REGULAR MEETING – PLANNING AND ZONING COMMISSION AGENDA

OCTOBER 22, 2025, 6:00 PM

- A. #2025-49 SP – Enrico R. Costantini, Esq. – 284 New Canaan Avenue – Request to modify Special Permit #12-16 to expand the area of the previously approved contractors yard and change the stormwater management - Continuation of public hearing, report & recommended action**

- B. #2025-56 SP/CAM – Alpha5MK 19 Day , LLC – 19 Day Street (District 2, Block 58, Lot 44) – Special permit for a proposed multifamily building with 32 units - Public hearing, report & recommended action
- C. #2025-59 R – RMS Real Estate Group, LLC – Zoning Regulation Text Amendment to Article 7 (Sign Standards) to create a “Cornice Sign” sign type and permit Cornice Signs within the CD-3C and CD-4 zones - Public hearing, report & recommended action

C-1.0

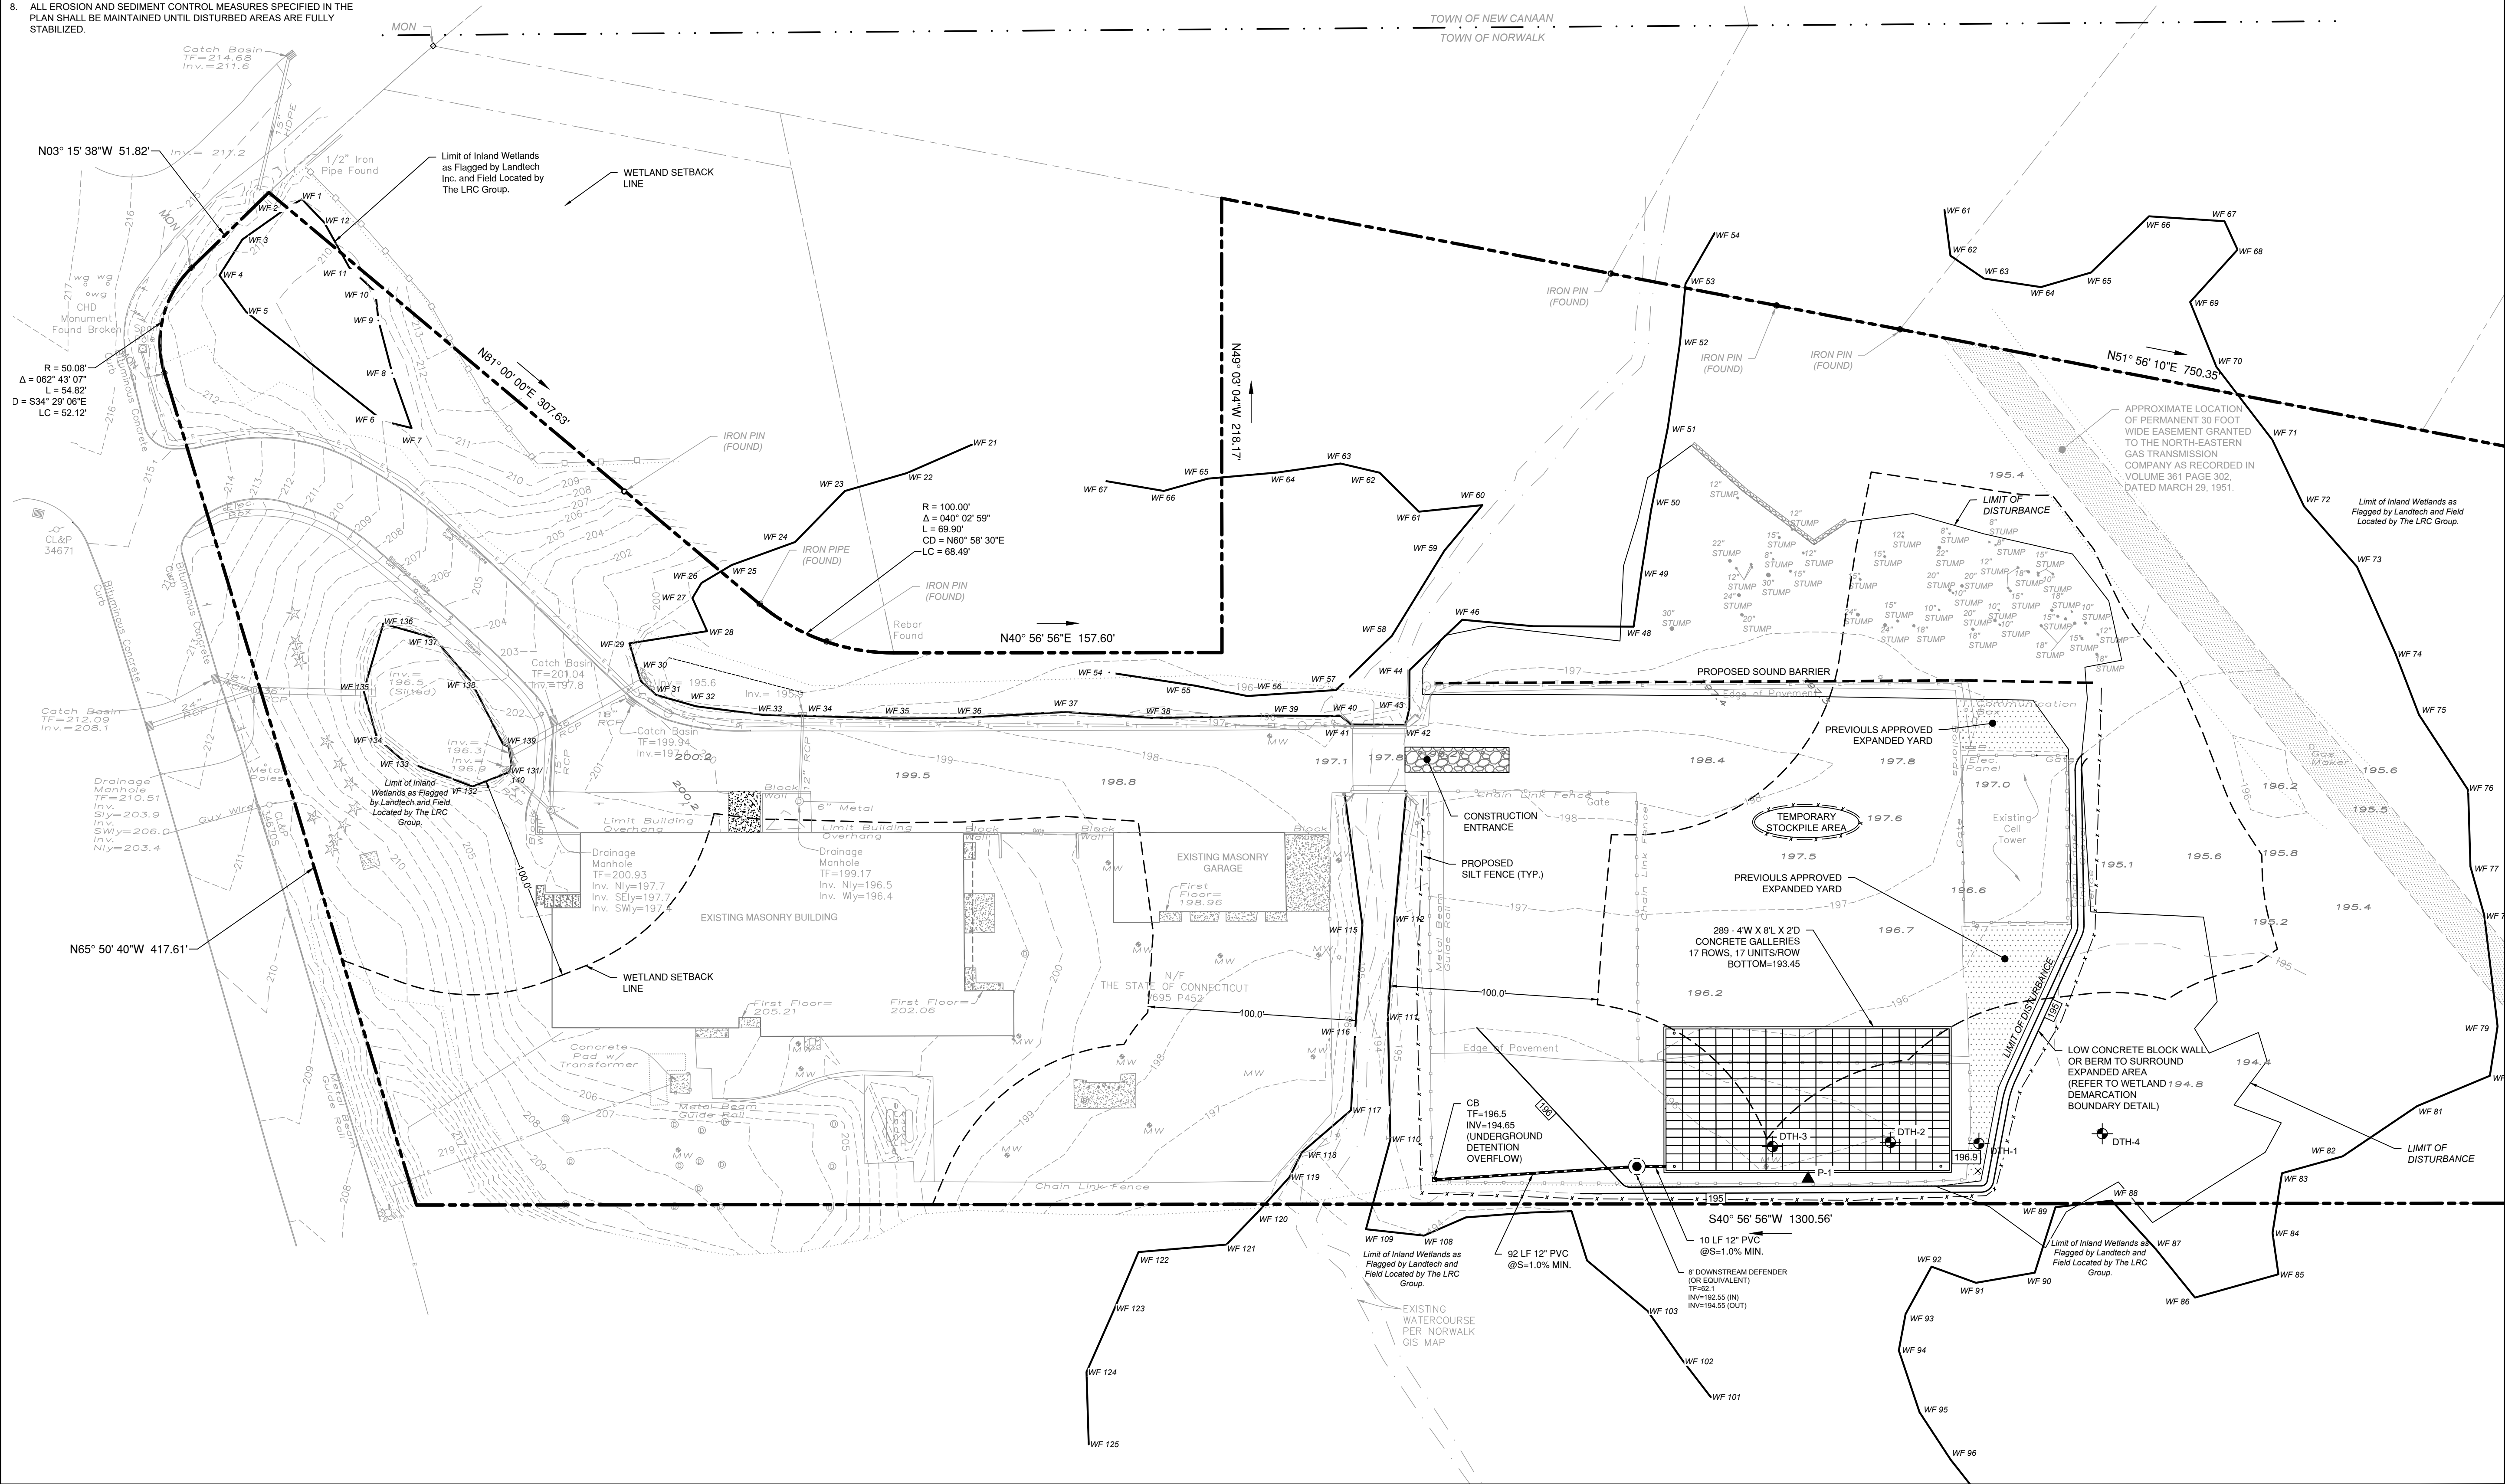
In our 2023 report, SHA recommended a 20' earthen berm with densely planted evergreens to maximize acoustic shielding for neighboring residences. Since this approach is no longer feasible, we have developed an alternate solution: a constructed barrier consisting of Mafia Blocks stacked to 13' with an 8' acoustical wooden fence extension, for a total height of 21' (Figure 6 and Figure 7). This barrier will be both incorporated into the rear-side construction of relocated material bins to the west of the Construction Yard and wrap around to the north side of the Yard as well.

The limits of the acoustical barrier have been expanded. The barrier will consist of a 13-foot concrete block wall with an 8-foot wooden sound fence installed on top, providing a combined effective height of 21 feet, as detailed in the SH Acoustics report and shown on the revised site development plans (Sheets C-1.0 through C-3.0, revised October 2, 2025)

The extent of this barrier is shown in LandTech's related submission package entitled, "Site Improvements for a Contractor's Yard," specifically on **Sheet C-1.0 – Site Development Plan** (dated 12/18/2024, revised through 10/02/2025)

1 EAST ELEVATION
SD2.01 1/8" = 1'-0"

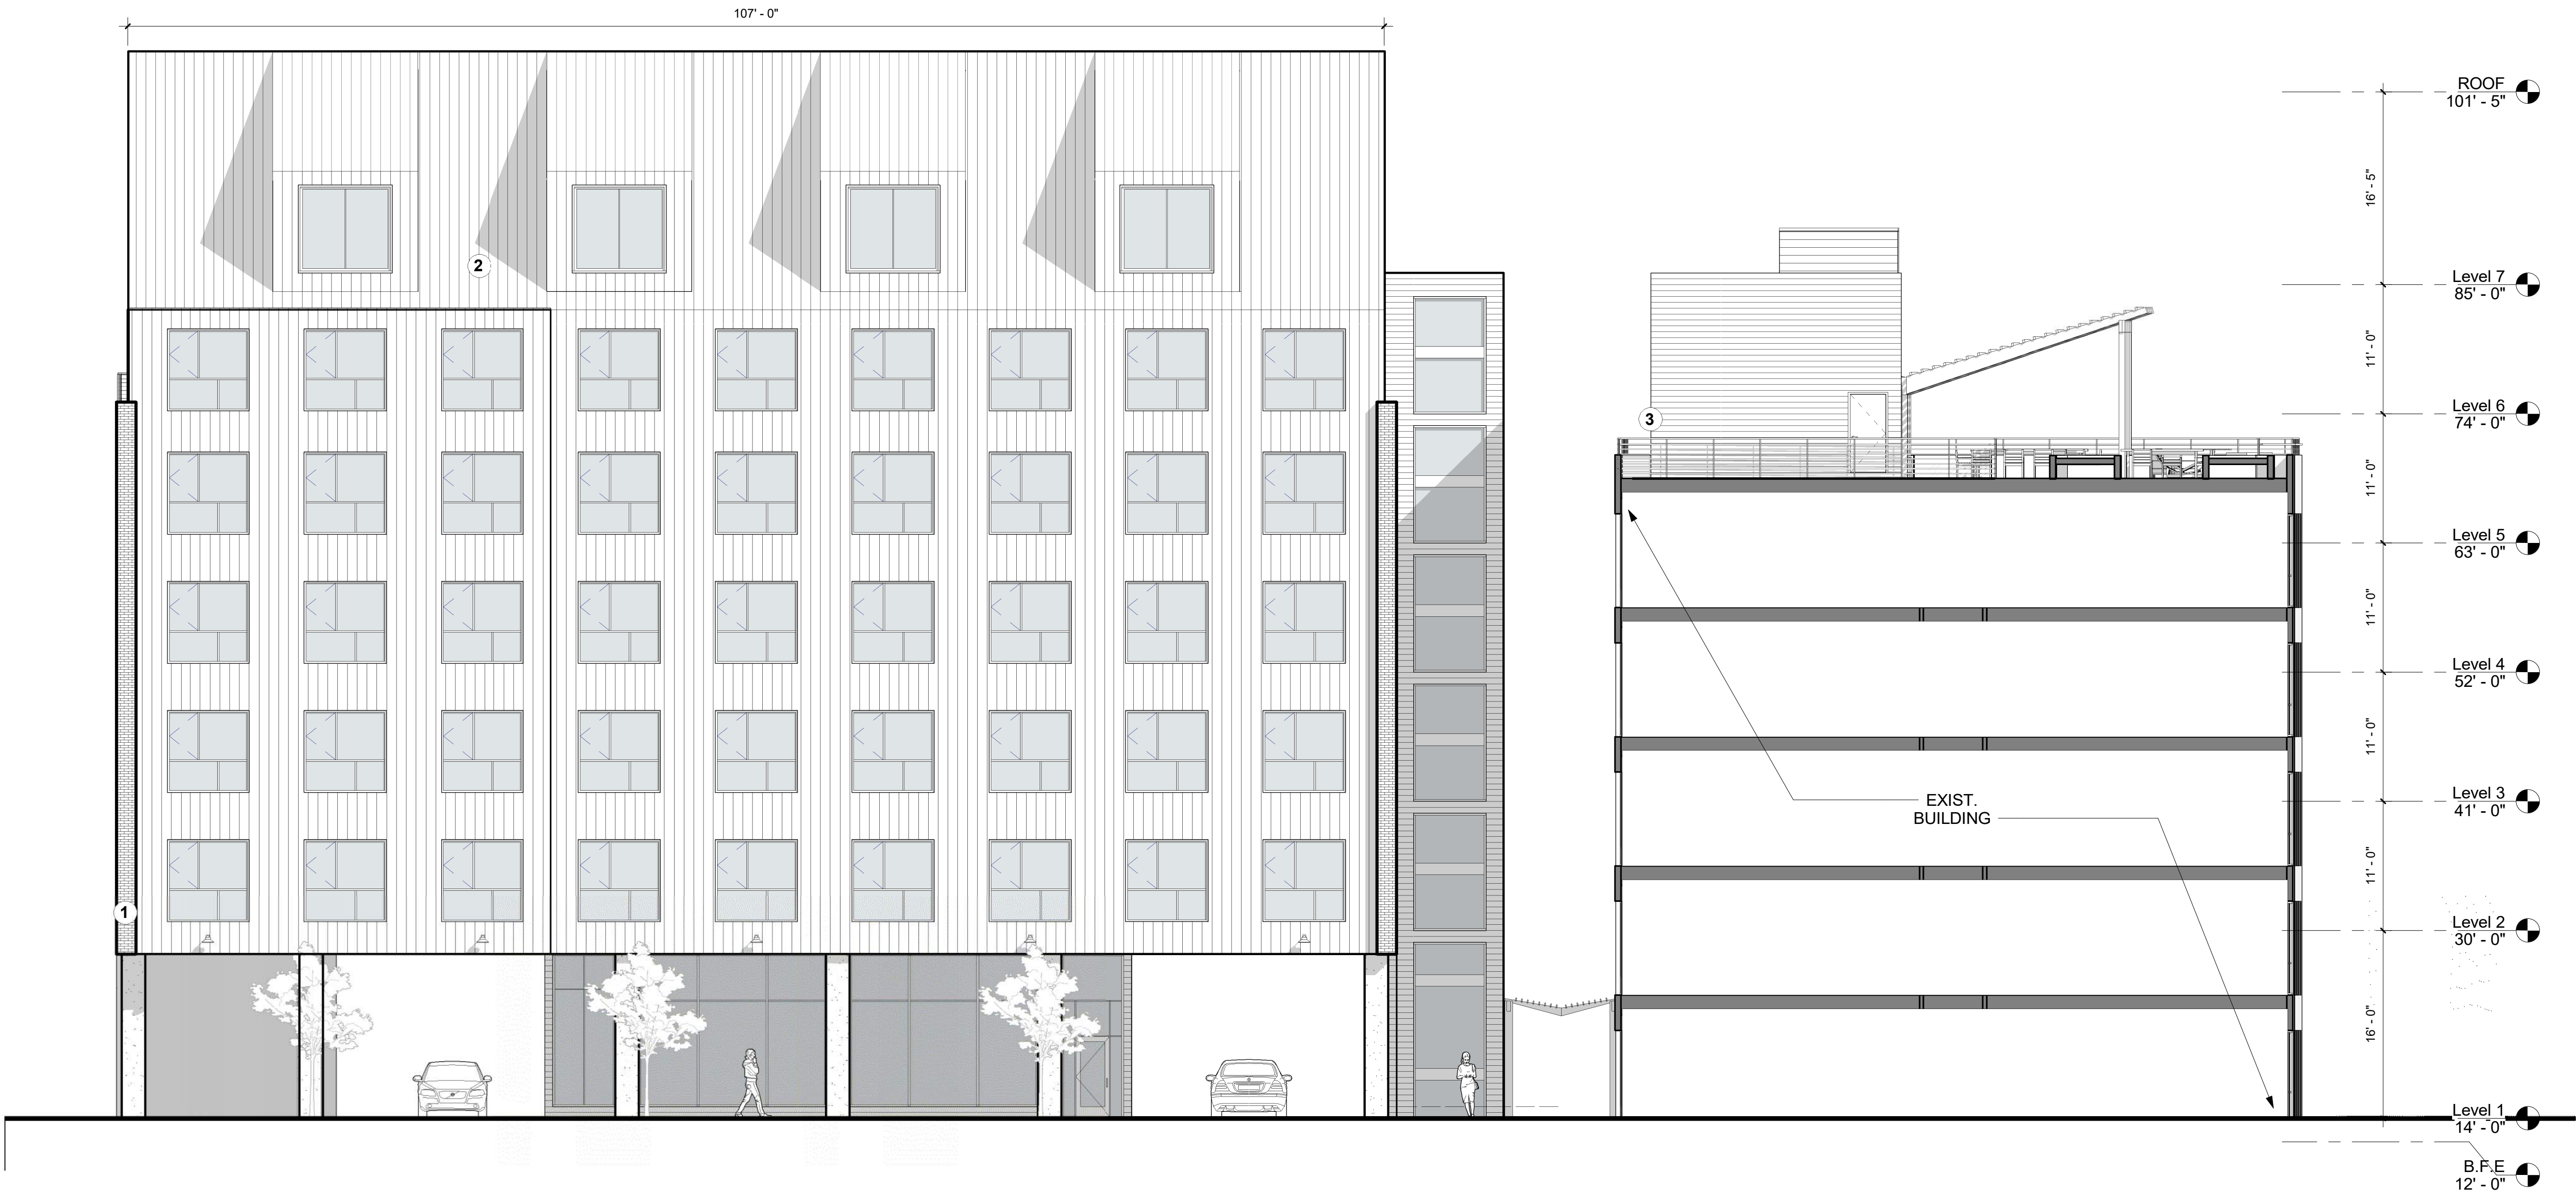
In Drawing SD9.10, the walls of the trash room/stair block are shown as glass, which appears similar to the lobby of the building. This material could be changed to another material compliant with the regulations to differentiate it from the glass lobby and prevent confusion for pedestrians entering from Day Street.

Electrical Room and Water Room are at FFE 14' (two feet above flood plain). Trash room stair block is not glass; they are fiber cement paneling. See SD2.01, all window glazing has a blue tint. Lobby has added detail to make intent clearer.
